# OCP NIC 3.0 Design Specification

Version 0.01

Author: OCP Server Workgroup, OCP NIC subgroup

Figure 6: Primary Connector (4C + OCP Bay) with 4C and 2C Add-in Cards

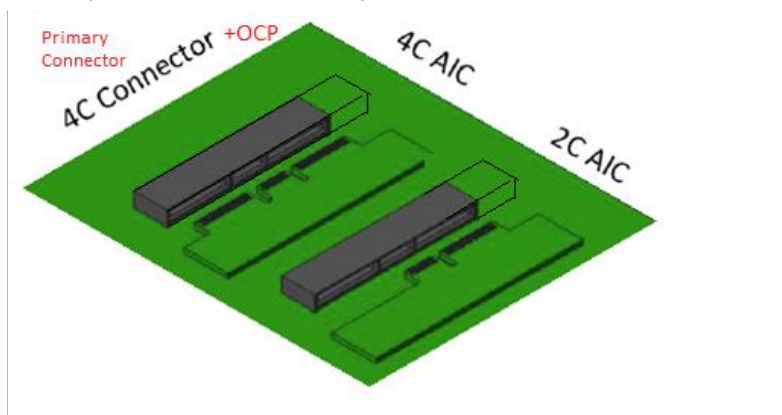
**Commented [TN4]:** This needs to be updated to show the OCP bay along with the secondary connector location..
